# Randwick Local Planning Panel (Public) Meeting

## Development Application Report No. D90/24

**Subject:** 129-129A Barker Street & 1 Maud Street, Randwick  
(DA/632/2024)

<b>Proposal:</b>	Demolition of the existing structures to enable the construction of 6-storey co-living housing development consisting of 84 rooms with one basement level for parking, storage and services
<b>Ward:</b>	West Ward
<b>Applicant:</b>	The Trustee For 29 Barker Street Unit Trust
<b>Owner:</b>	29 Barker Street Pty Ltd & Ms M J Hope
<b>Cost of works:</b>	\$17,321,700
<b>Reason for referral:</b>	The development involves demolition of an Interim Heritage Order (IHO) at 1 Maud Street, Randwick; eighteen (18) unique submissions by way of objection were received; and the development contravenes the development standards for communal living area, communal open space, and landscape area by more than 10%, pursuant to section 68 of the Housing SEPP.

Figure 13: Block D control plan in Part E7 of RDCP 2013 (Source: Randwick City Council)

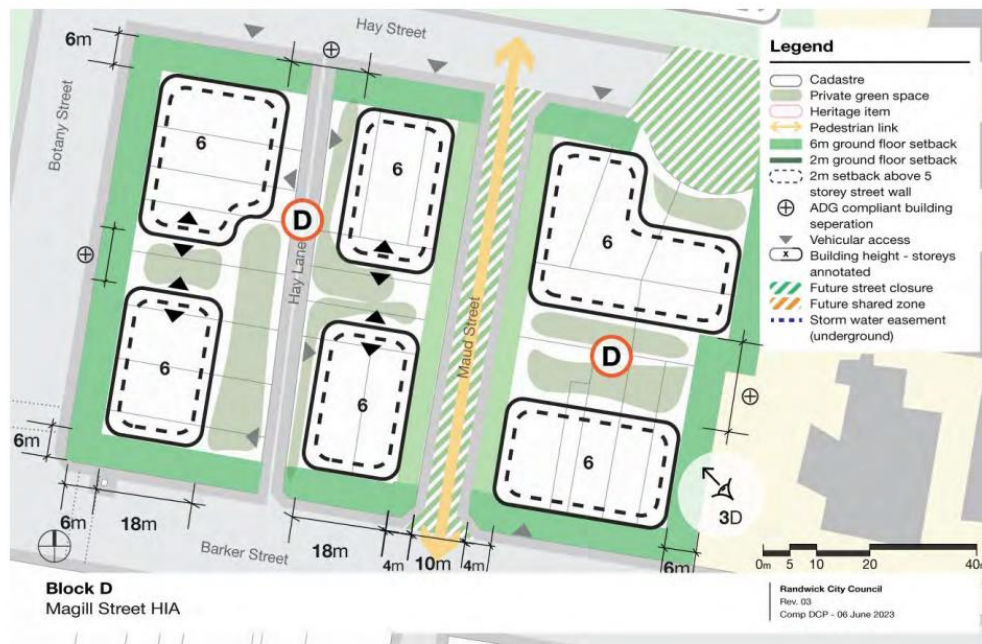
The proposed development seeks to vary the block control intended in the DCP, as depicted in Figure 14 below.

Figure 28 'Block D control plan' in Part E7 of the RDCP 2013 in the relevant block diagram for the site. The diagram demonstrates that the northern side of the site shall be occupied by 'private green space'.

Figure 14: Proposed development overlay on the Block D control plan in Part E7 of RDCP 2013 (Source: Randwick City Council)

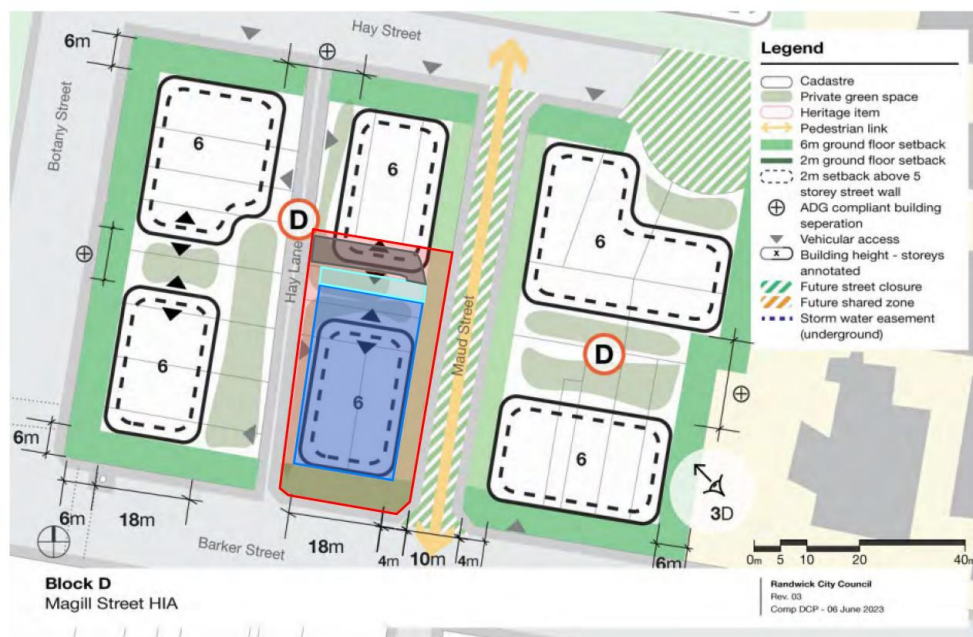
Figure 14 shows the following mark ups by Council:

Overall, Council is not supportive of the proposed development in that it does not comply with the Block D control plan, seeking to vary a number of the features of the Magill Street HIA as intended for the desired future character of the site. This includes the following variations:

- Removal of 2 trees being T6 and T7, varying the controls to retain trees with considered site planning.
- Driveway and Crossing:
  - Proposed driveway/basement ramp is located across the rear boundary in the northwest site corner, varying the control plan to locate the driveway integrated into the building design.

Council is concerned regarding the existing and future potential building separation. The proposed development seeks to increase the length of the building, varying the block diagrams controls in the RDCP 2013. The applicant has failed to model what the Block D plan will result, should the variation to the building envelope be supported. This includes confirming that there is sufficient separation between possible future buildings in the block for future development of sites, including but not limited to, 3-7 Hay Street.
